NUREG-0139

# **environmental statement**

## **CLINCH RIVER BREEDER REACTOR PLANT**

**FEBRUARY 1977**

FIGURE 2.6 Population Distributions for 1970 and 2010 within 5 Miles and 50 Miles of the Site

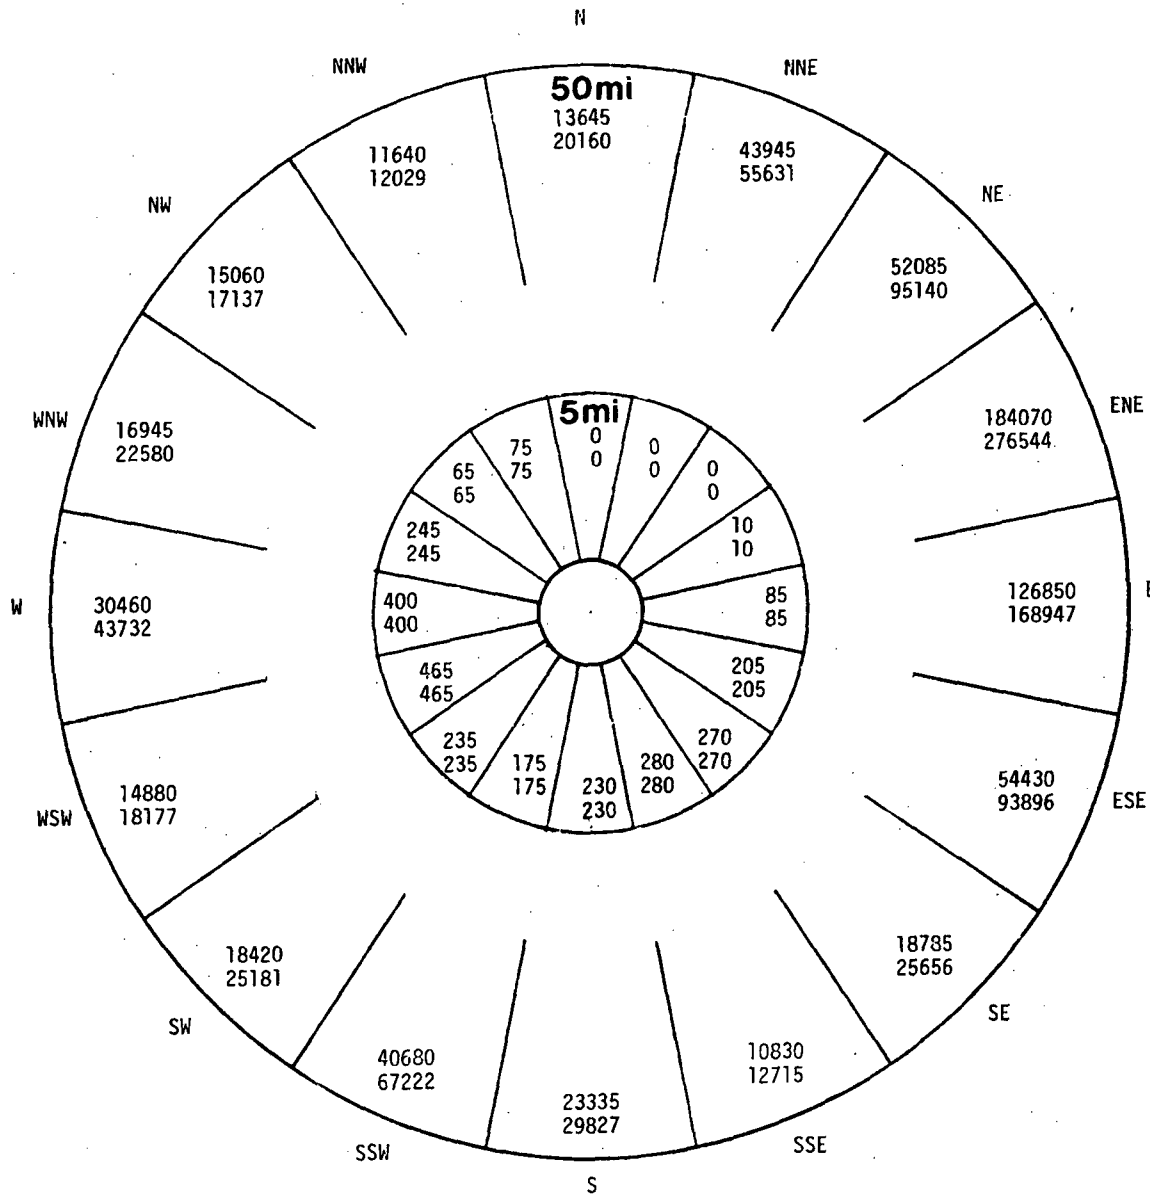
8. Include a political jurisdictional map, i. e., showing boundaries of the authority of planning commissions, fire districts, water districts, etc.
9. Section 2.2 and Fig. 2.6 may be misleading. Growth within a five-mile radius was projected in the applicant's Environmental Report since it contains a large percentage of the potential locations for trailer parks for construction workers, whereas, the DES projects no growth within this five-mile radial area. Also, long-range growth of residential Oak Ridge includes areas within five miles of the site. Moreover, depending on what portion of the site one takes as the center of the circle of radius of five miles, there may be no residences to the north, but there are always people to the north at the ORGDP and the Clinch River Industrial Park. Any discussion of population concentrations should take into consideration day and night time variations related to community activities.

Section 2.2 is expanded to recognize the ORGDP, ORNL, and other workers within 5 miles, in addition to the references to them in Sections 2.1 and 2.8. The 2010 estimates shown in Figure 2.6 are taken from the ER. (Sec 2.2.1.1, par 5 and 7 including Tab 2.2-4 through 2.2-7.) The staff notes the possibility of temporary mobile home locations within 5 miles during construction, depending upon future decisions of the city government.

FIGURE 2.7 Archaeological and Historical Sites

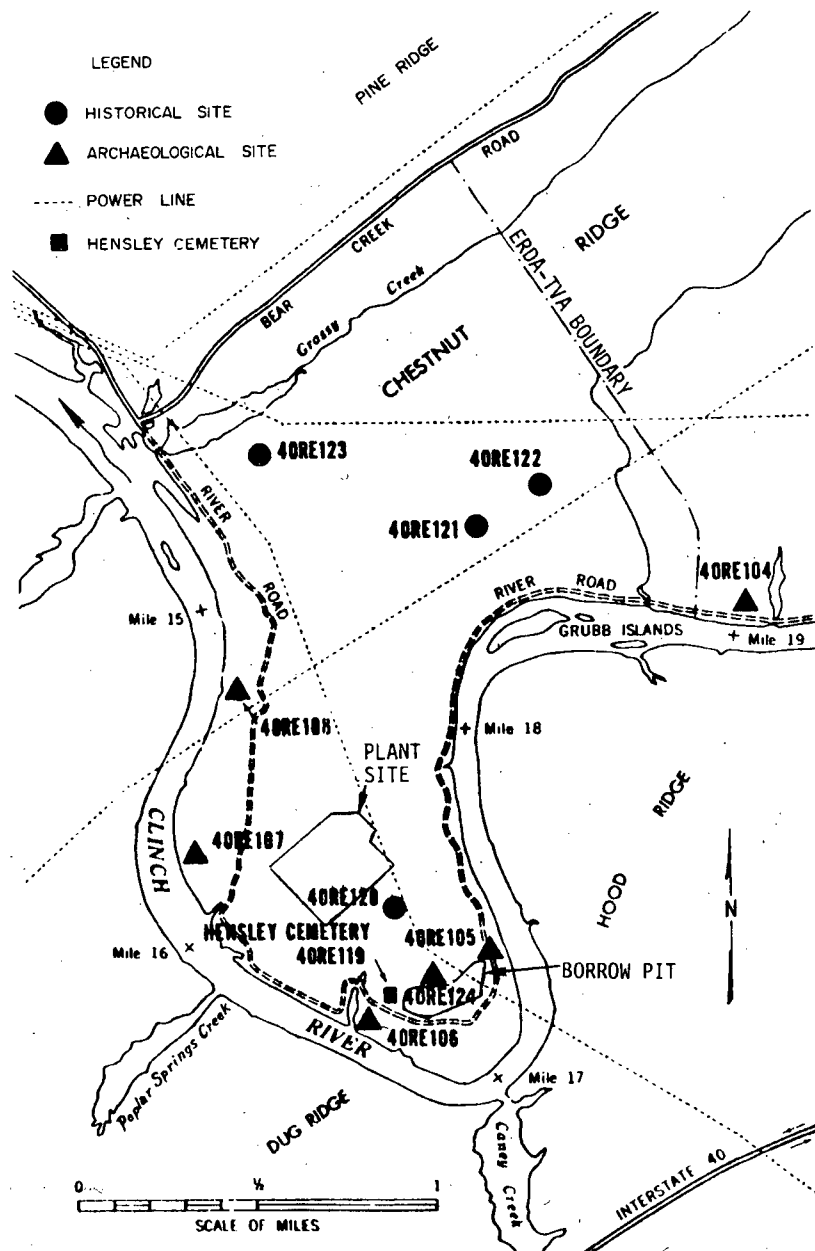
Figure 2.7 should indicate construction areas.

The Advisory Council on Historic Preservation states that historic and archaeological values receive adequate consideration in the DES (page A-2). The staff considers the discussion in Section 2.3 adequate in view of the anticipated impacts, which are judged to be small (Sections 4.2.1 and 5.1). Construction areas have been added to Figure 2.7. Refer also to Figures 2.3 and 3.3.

FIGURE 3.8 Intake Pipe

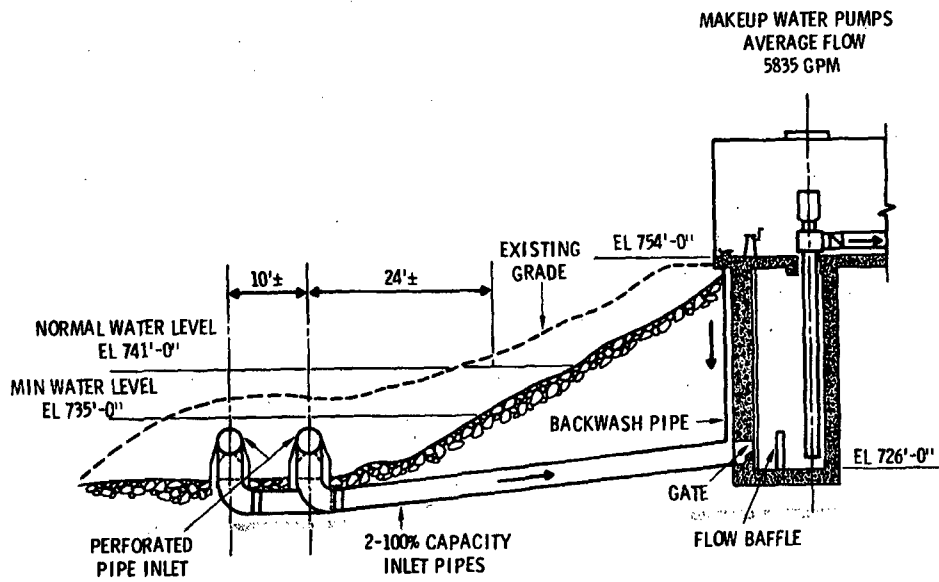
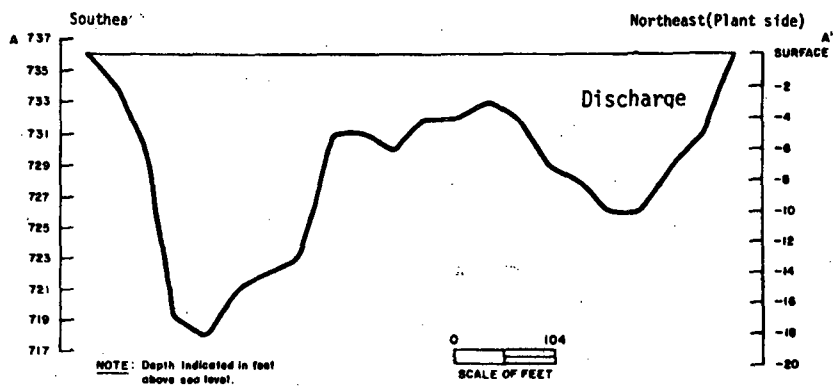
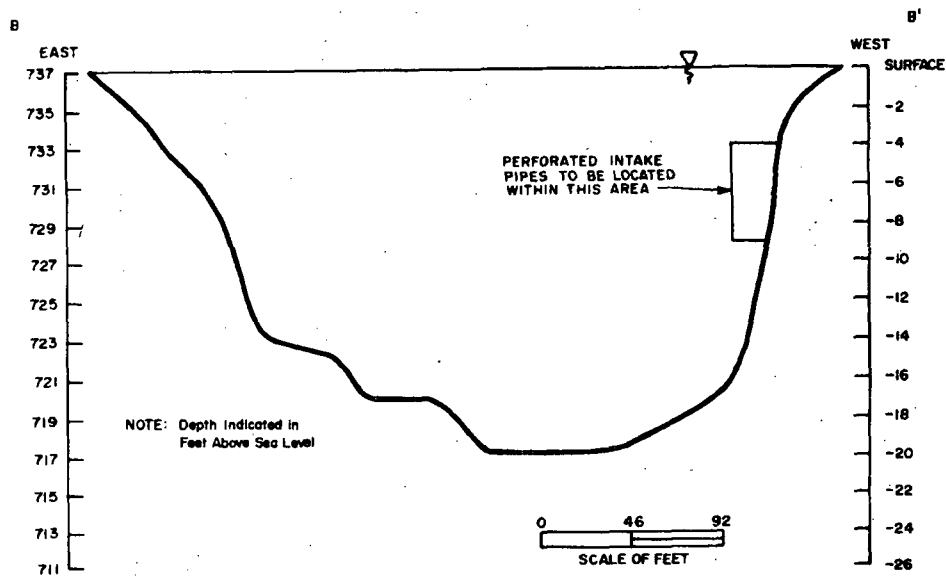
Figure 3.8 shows the tops of two intake pipes at approximately elevation 733 msl or higher. Figure 3.14 shows "intake pipes to be located within this area," the top of which is 724 msl. These figures should be checked for errors or discrepancies.

Figures 3.8, 3.12 and 3.14 have been revised in accordance with the Project's revised permit application to the Corps of Engineers (Caffey; July 8, 1976). Both the intake and discharge structures are recessed into the river bank to avoid obstructing navigation.

FIGURE 3.16 Gaseous Radioactive Waste Systems and CRBRP Ventilation

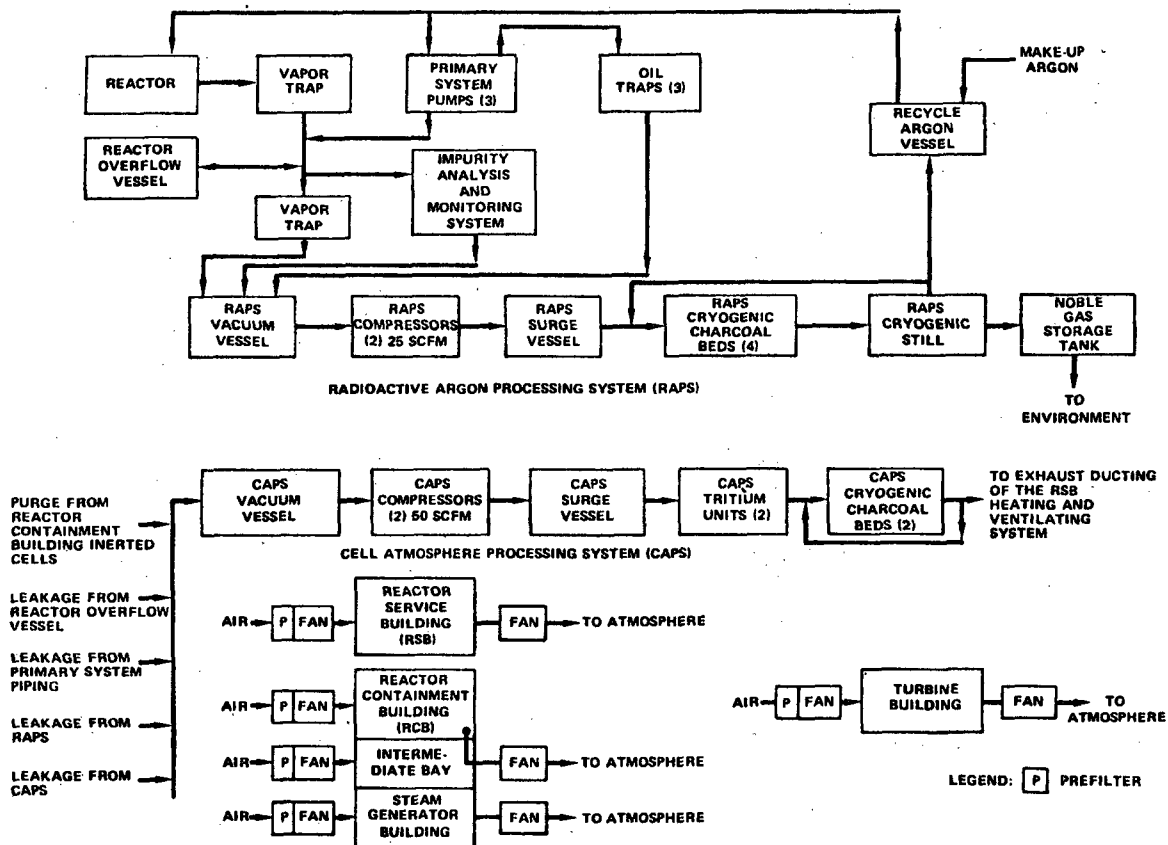
The schematic of the radioactive gas processing system in WASH-1509 (p.50), unlike the schematic in Figure 3.16 in the DRAFT (p.3-15), does not show a flow path from the noble gas storage tank to the environment.

FIGURE 3.17 Chemical Waste Treatment System

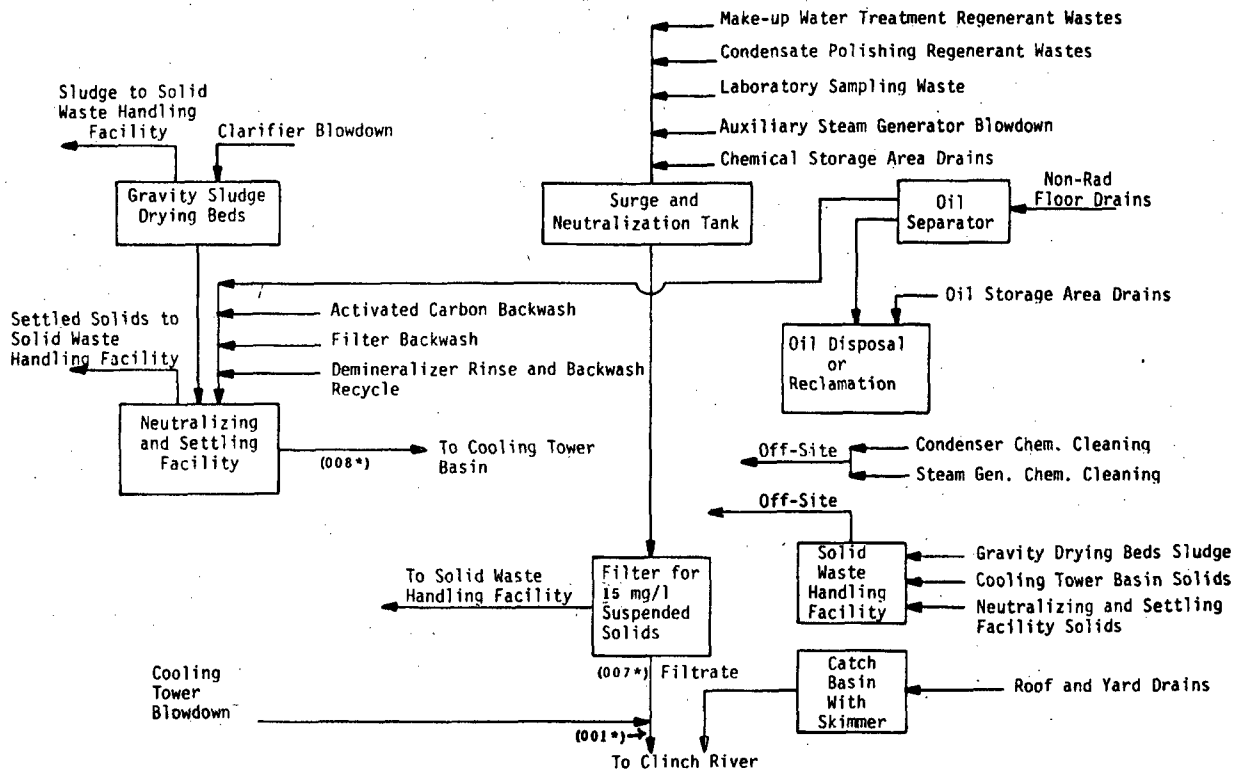
10. The provisions for a filter in the cooling tower blowdown shown in DES Figure 3.17 were initially included since they may have been required to comply with proposed suspended solids guidelines. The filter has now been deleted from the CRBRP design as it is not required per 40 CFR 423.

FIGURE 6.2 Reservoir Monitoring Network for CRBRP (ER, Fig. 6.2-2)

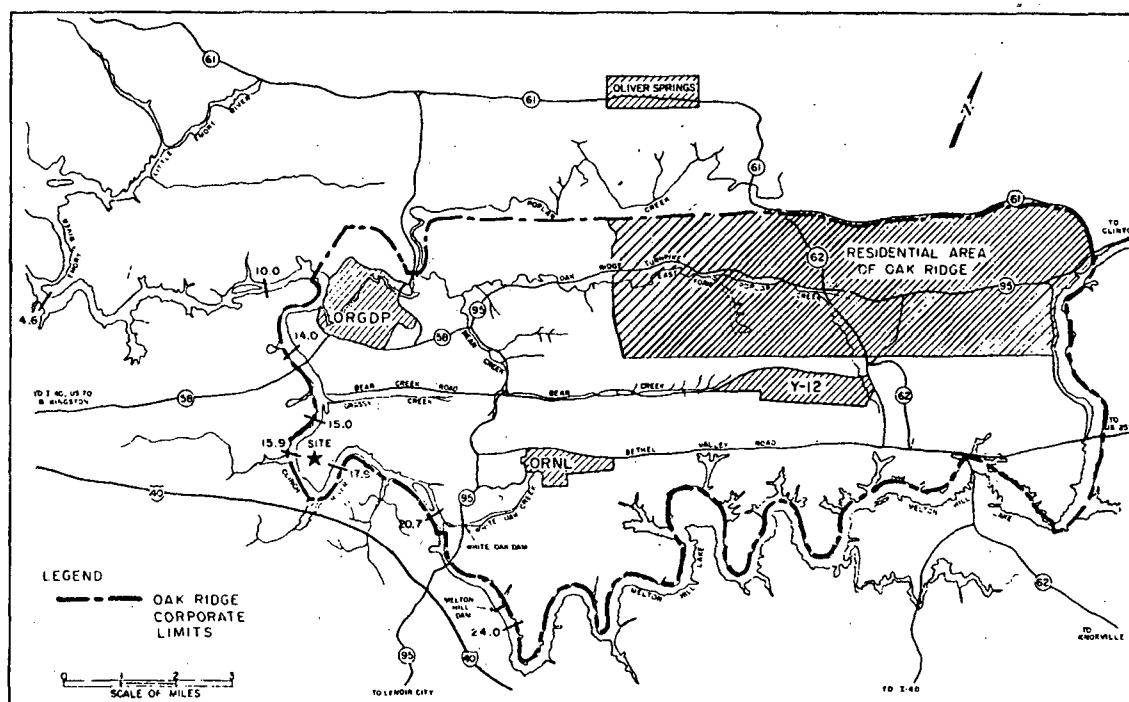
The pre-operational monitoring program at reservoir locations does not list these locations and the accompanying Figure 6.2 has no legend (pages 6-2, 6-3). In the later design of the operational radiological monitoring program (page 6-11), consideration should also be given to monitoring of storm drainage from buildings and yards, among other items.

The political jurisdiction of Oak Ridge is shown on Figure 6.2 as revised. Showing the boundaries of the service districts cited in the Oak Ridge comment is not essential to this statement. However, the staff's assessment of costs of municipal services resulting from the project is intended to include additional costs to the service jurisdictions.

Revised Table 6.1, along with Figures 6.1 and 6.2, should adequately identify the reservoir locations where samples will be taken. Consideration will be given to monitoring storm drainage from buildings and yards in design of the operational monitoring program.
